# Economic and Social Council

### Inland Transport Committee

### Working Party on Passive Safety

## Report of the Working Party on Passive Safety on its sixty-first session

Figure 16  
Schematics of how to measure wrap-around distance

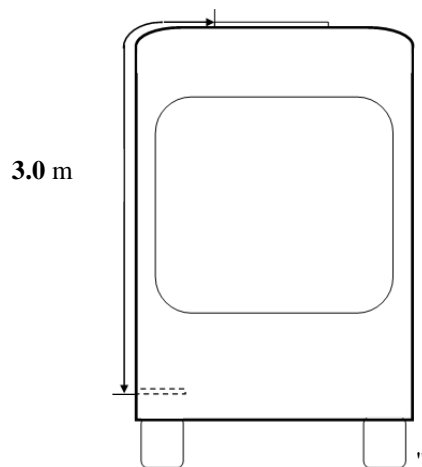
High voltage live ... of the vehicle. For Category 1-2 vehicles the minimum wrap around distance from the instep of the vehicle to the roof mounted charging devices is 3.00 m. In case of multiple steps due to elevated floor inside the vehicle, the wrap around distance is measured from the bottom most step at entry, as illustrated in Figure 16.

**Splashing test nozzle**

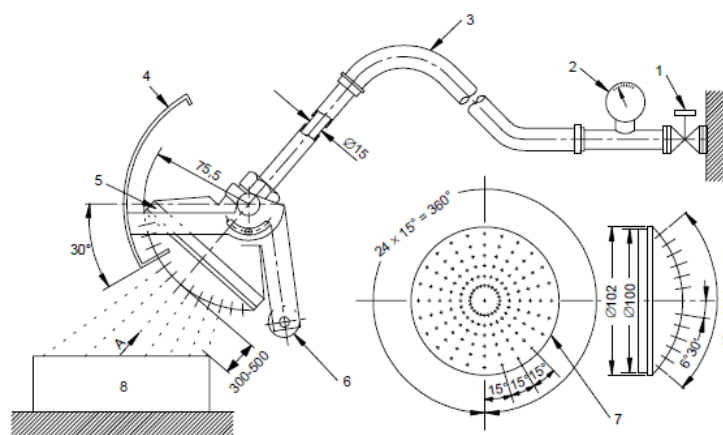
Figure 2, modify the entire figure including the notes:

Figures of Strapped child

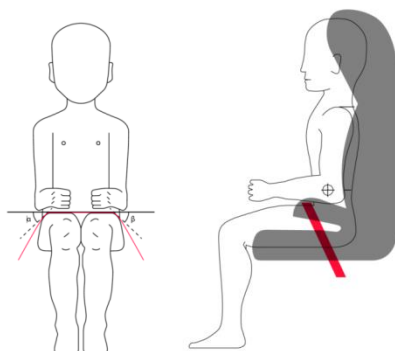
**In the case of booster cushions and booster seats , the lap portion of the adult seat belt shall be positively guided on both sides to ensure that the loads which are transmitted by the adult lap belt are transmitted through the pelvis. The positive guidance of loads over the pelvis shall be realised from the moment that the child is installed; the lap belt shall pass over the top of the thigh, just touching the fold with the pelvis. The angles  $\alpha$  and  $\beta$  between the tangent line in which the belt touches the thighs and the horizontal shall be greater than 10°.**

**Arrangement for testing a rearward-facing device, not supported by the dashboard**

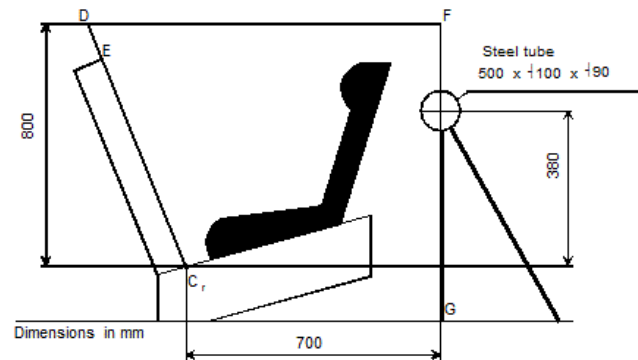
- "6.6.4.1.2.1. Head excursion: no part of the head of the dummy shall pass beyond the planes FD, FG and DE, as shown in Figure 2 below. This shall be judged up to 300 ms or the moment that the dummy has come to a definitive standstill whatever occurs first.

The value in relation to the FD plane is 840 mm.

**ECRS Measurement Device - Side and Front View of the measuring device**

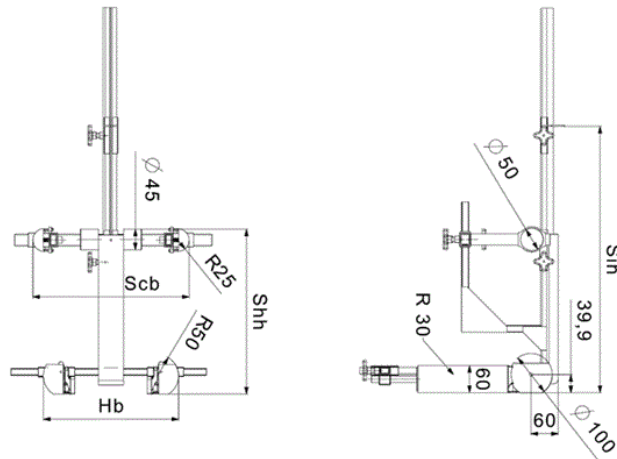
All lateral dimensions are measured under a contact force of 50 N with the devices described in Figure 2 and Figure 3 of this annex and the following tolerances will be applied:

The mass of the devices described in Figure 2 and Figure 3 of this annex shall be 10 kg  $\pm$  1 kg

Arrangement for testing a rearward-facing device, not supported by the dashboard

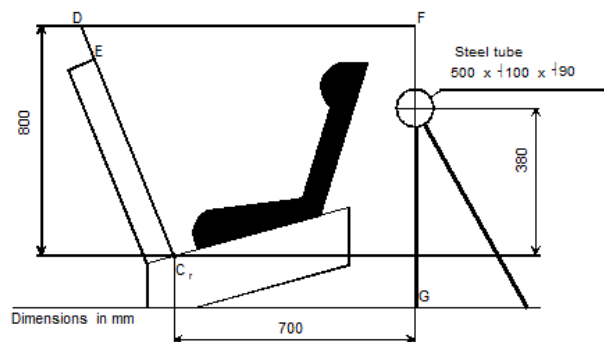
"6.6.4.1.2.1. Head excursion: no part of the head of the dummy shall pass beyond the planes FD, FG and DE, as shown in Figure 2 below. This shall be judged up to 300 ms or the moment that the dummy has come to a definitive standstill whatever occurs first.

The value in relation to the FD plane is 840 mm

**ECRS Measurement Device - Side and Front View of the measuring device**

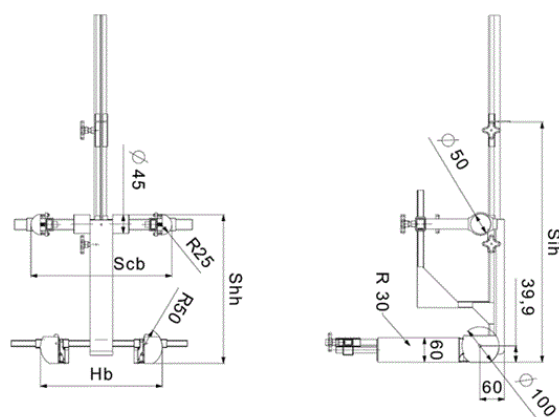
All lateral dimensions are measured under a contact force of 50 N with the devices described in Figure 2 and Figure 3 of this annex and the following tolerances will be applied:

The mass of the devices described in Figure 2 and Figure 3 of this annex shall be 10 kg  $\pm$  1 kg
